**SUBJECT: VARIANCE / CLASS 3 SITE PLAN REVIEW / CLASS 2 ADJUSTMENT CASE
NO. VAR-SPR-ADJ22-02
5775 COMMERCIAL STREET SE - 97306
AMANDA NO. 22-116638-PLN AND 22-107794-RP**

Summary: Proposed development of a new mixed-use building containing 71-dwelling units and 11,998 square feet of retail commercial floor area.

SITE PLAN
1 TRASH / RECYCLE

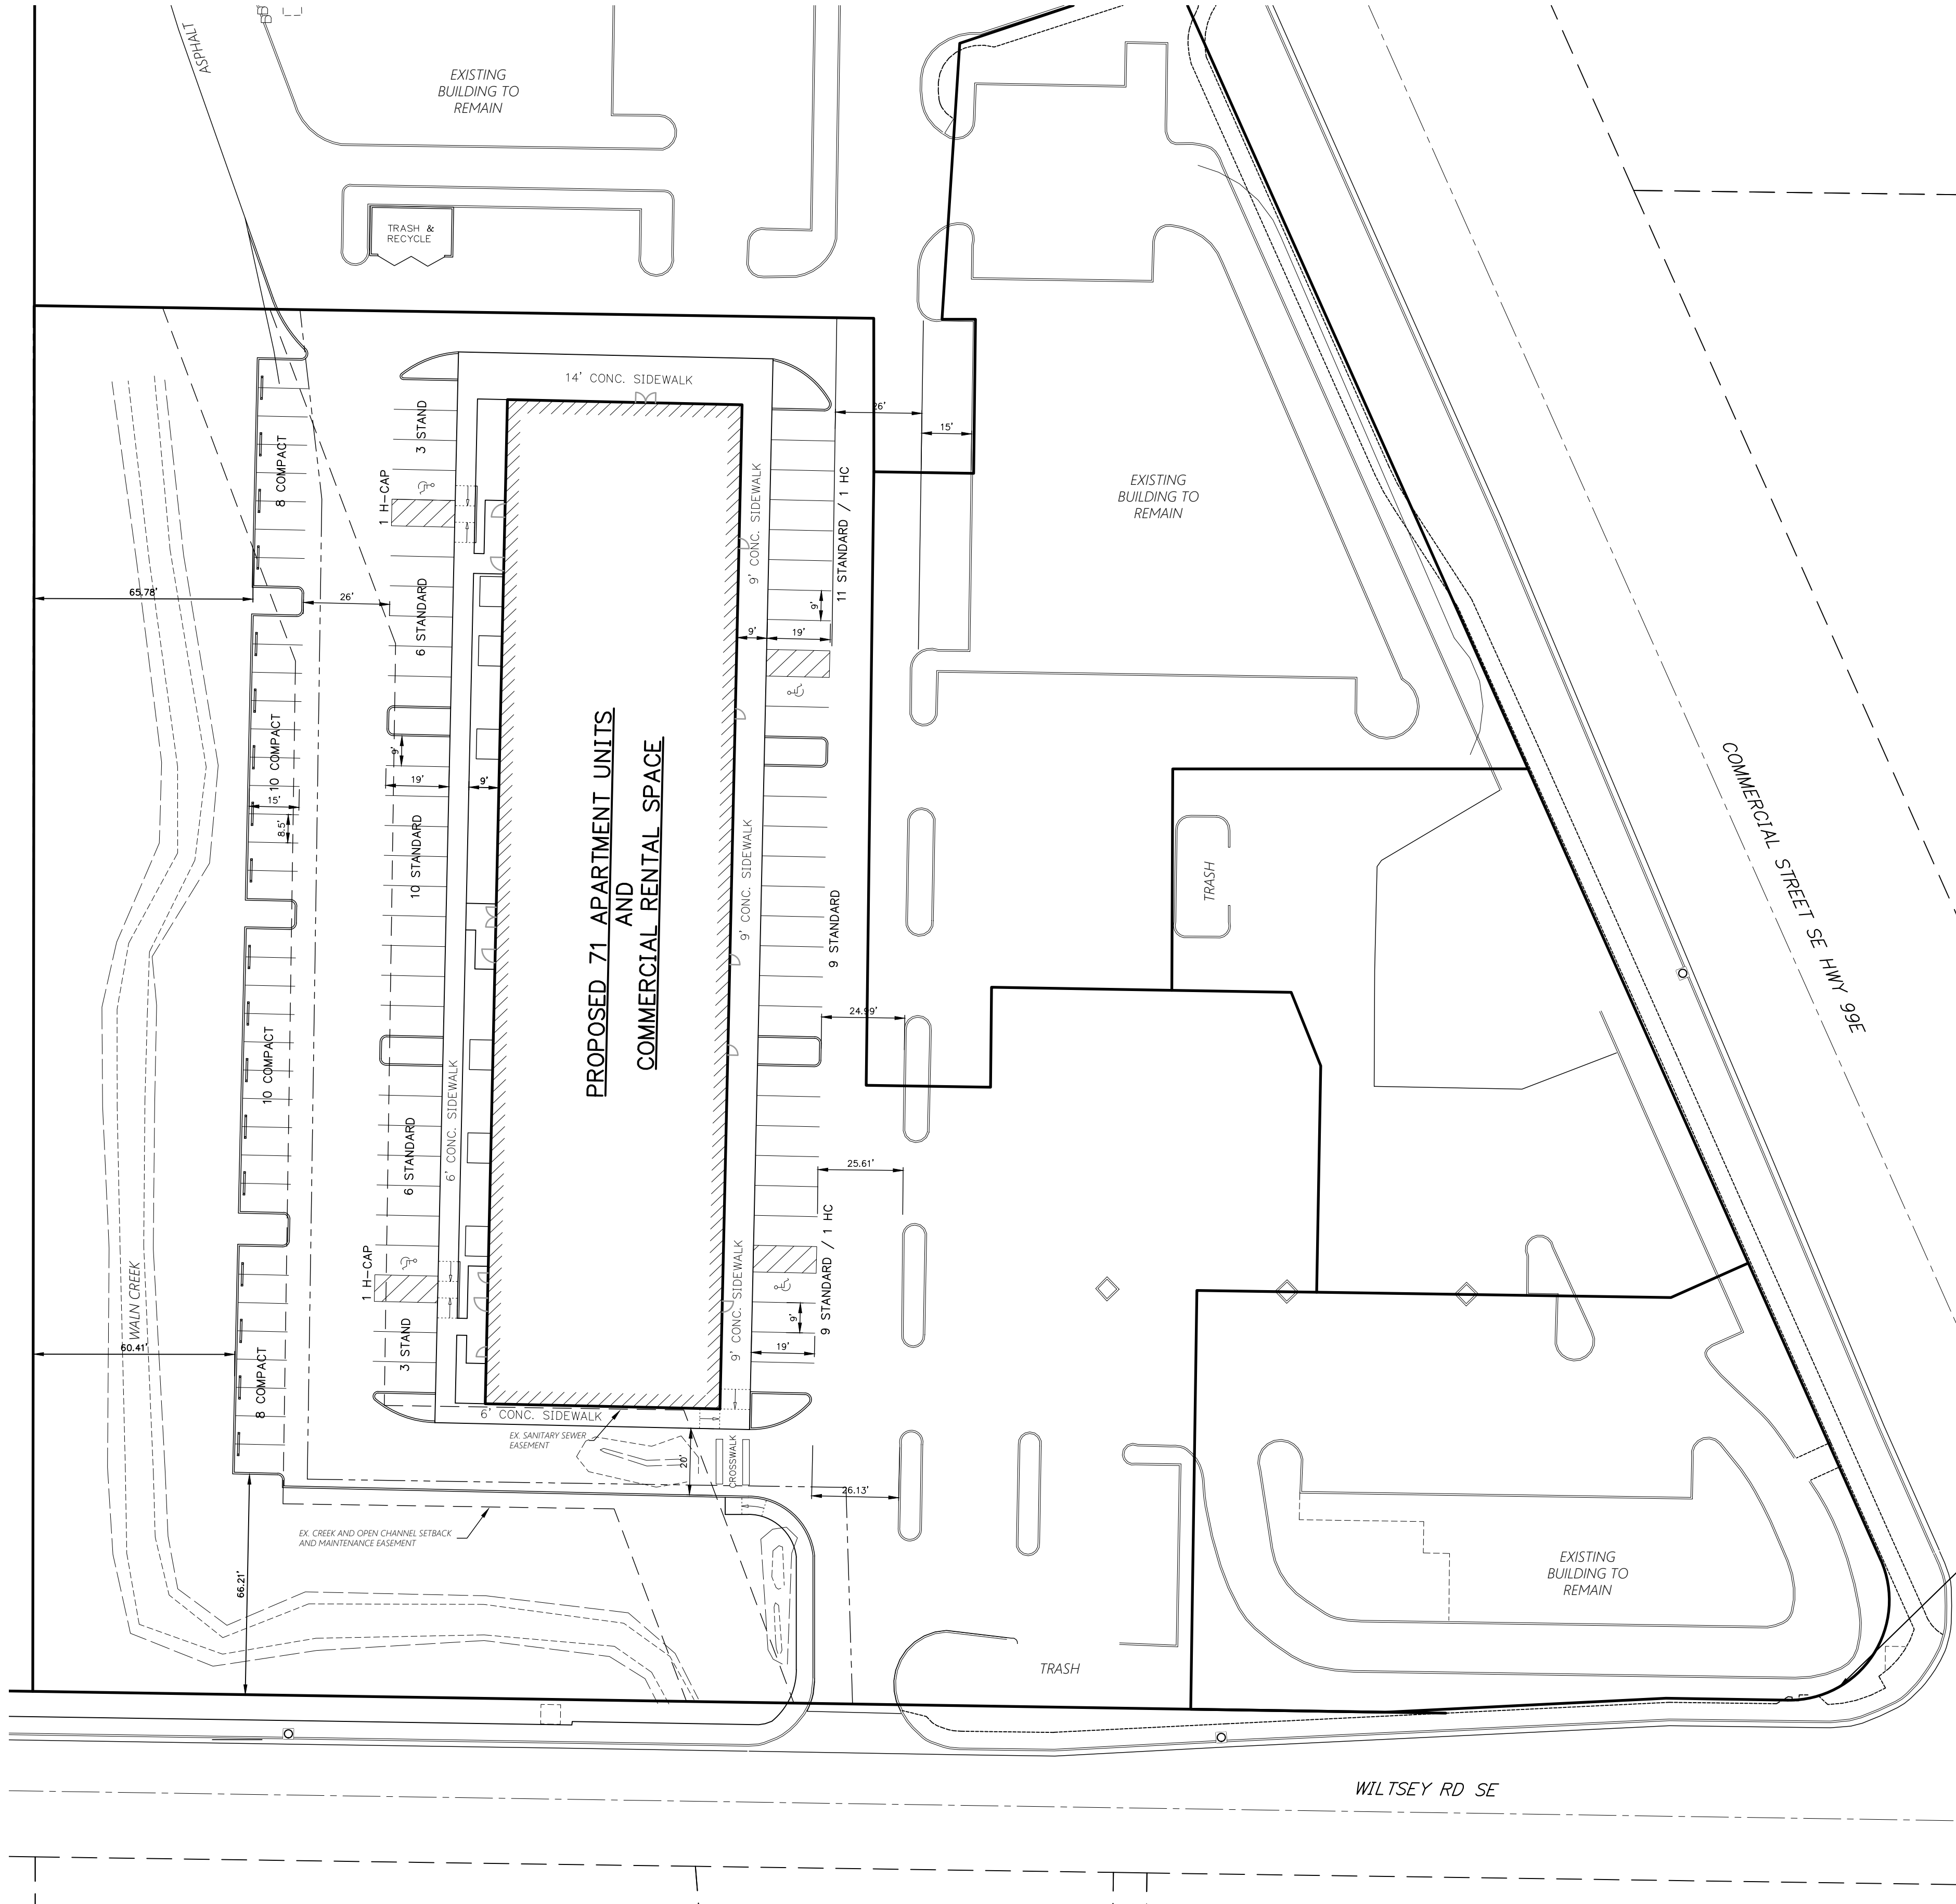
Finding: The proposed site plan does not show any pedestrian connections provided between the mixed-use building and the other existing buildings on the development site. The applicant has requested an adjustment to eliminate the requirement to provide pedestrian connections between buildings located on the same development site. Findings for the Adjustment request can be found in Section 8 of this report.

The maximum off-street parking allowance is 1.75 times the minimum requirement, or 287 spaces ($191 \times 1.75 = 286.5$). There are currently 248 off-street parking spaces provided for the existing development site, the proposed site plan indicates that 95 new off-street parking spaces will be provided for a total of 344 off-street parking spaces which exceeds the maximum allowance for the development site.

Finding: Bicycle parking is not indicated in the applicant's development plans, as conditioned, at the time of building permit the applicant is required to demonstrate that required bicycle parking complies with the minimum amounts specified in Table 806-9 and all applicable development standards of SRC Chapter 806.

Condition 5: Prior to building permit approval the applicant shall provide an updated site plan and parking analysis demonstrating the off-street parking requirements of SRC Chapter 806 are met for the development site.

Condition 9: The applicant shall provide pedestrian connections between the proposed mixed-use building and existing buildings to the north (5755-5757 Commercial Street SE) and to the east (5765 Commercial Street SE) in compliance with the development standards of SRC Chapter 800. A pedestrian pathway leading from the proposed mixed-use building to 5795 Commercial Street SE is not required.
